Comments received prior to Draft Scoping Report release

**Subject:** Rössing Uranium Ltd - SEIA for the proposed mining of the Z20 Uranium deposit

#### Uranium-238 concentration in underground water samples

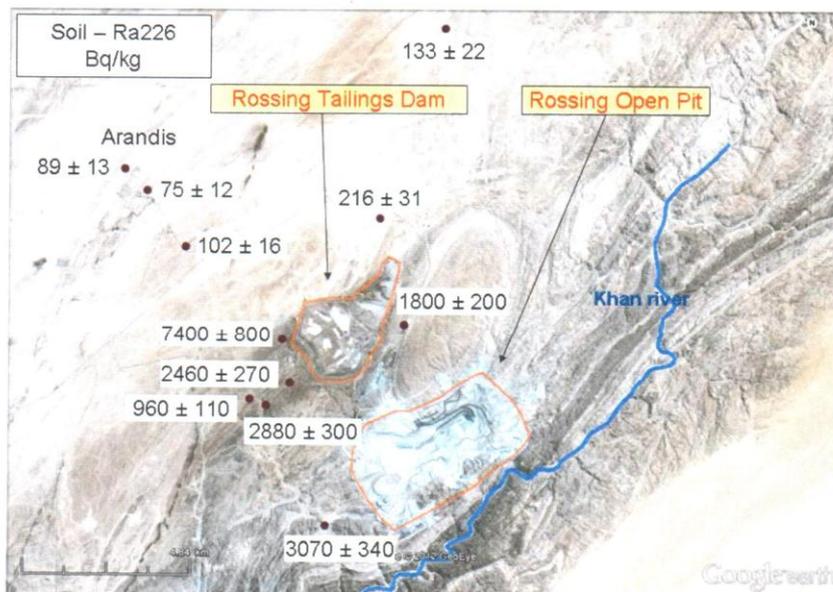
- 4) You might be aware that on Earthlife's request the Commission for Independent Research and Information on Radioactivity (CRIIRAD) in 2011 took samples of sediment, soil and water in the vicinity of the current Roessing Uranium Mine. Although the results of these samples still have to be compared with monitoring data gathered over a long period by Roessing and Water Affairs, the preliminary findings show uranium-238 contamination of underground water (as well as soil and sediment) downstream the Roessing Uranium Mine in the Khan and Swakop River alluvium (please see results below).

This raises the question of the origin of uranium-238 contamination.

The current waste rock dump is very near the Khan River. CRIIRAD's measurements reveal high radioactivity of some rocks which may contribute to uranium-238 contamination.
